Lower Wisconsin River Watershed
Comment Form

Comment pertains to:
DFIRM Panel # 550522 0150 A **Comment #** 1 **Other** _____

FOR COMMENT #3

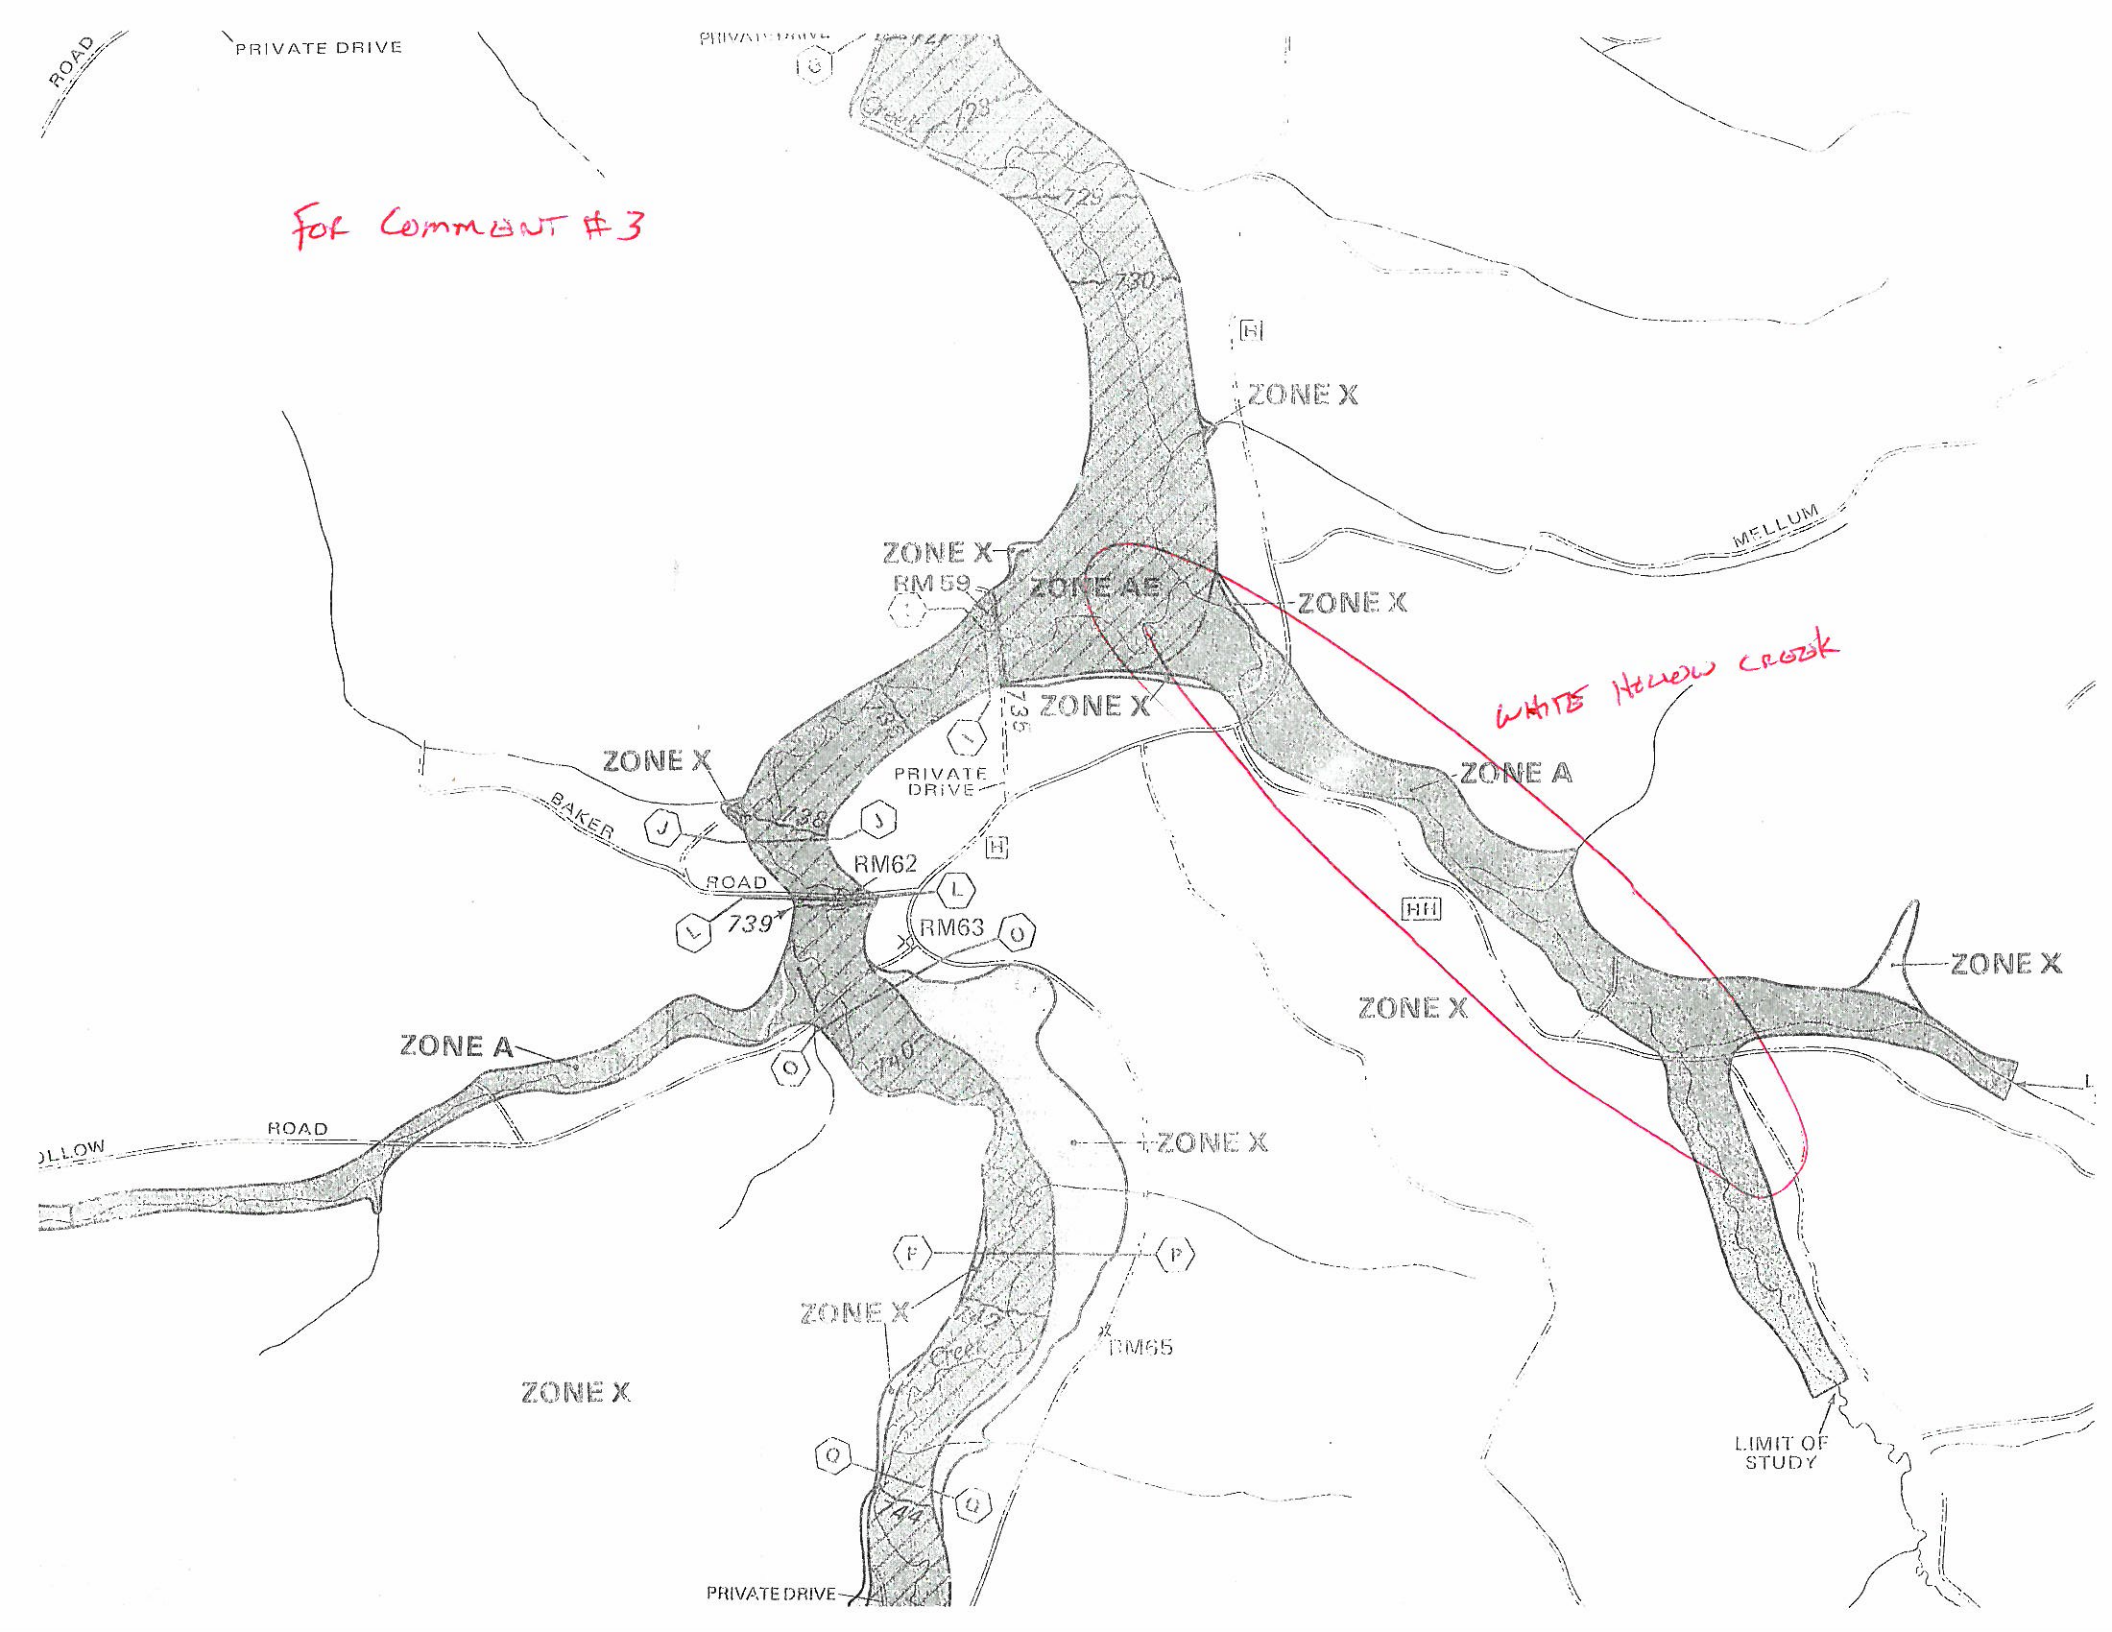
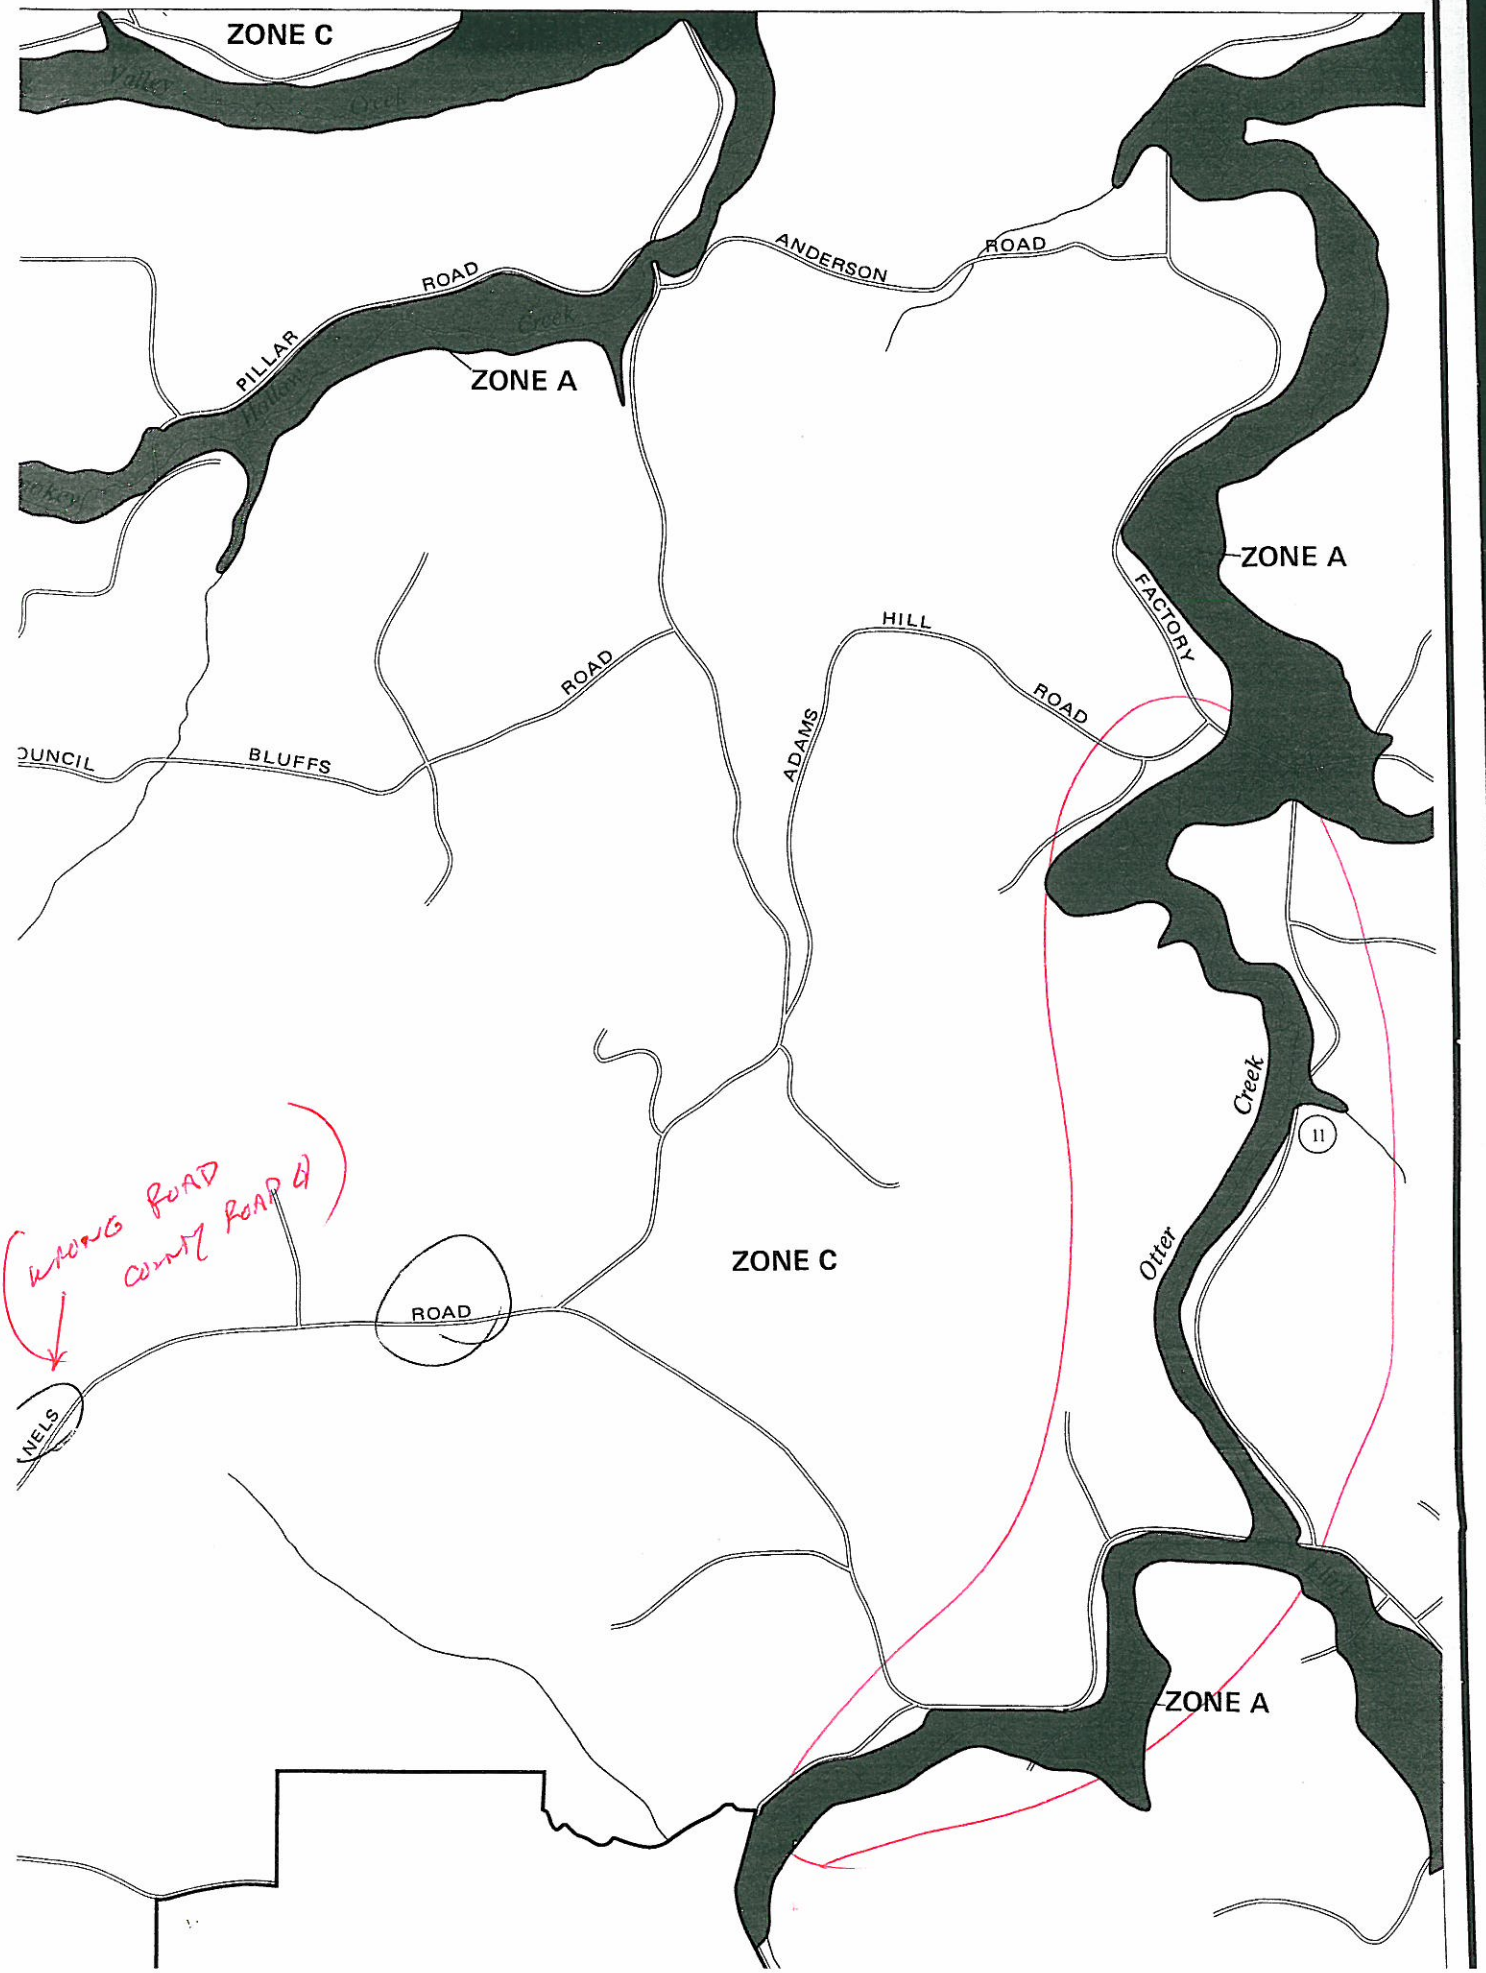
THE COUNTY HAS BREACH DATA FOR A NUMBER OF PL-56 DAMS THAT MAY ASSIST IN ESTABLISHING ZONE AS & DETAILED ZONE AES WHERE CURRENTLY NOT MAPPED. PANELS IMPACTED:

(A) 550522 0075 B : WHITE HOLLOW CREEK ALONG CO RD HH

550522 0125 A : OTTER CREEK ; FLINT CREEK

550522 0150 A : DOESLER CREEK ; TROUT CREEK
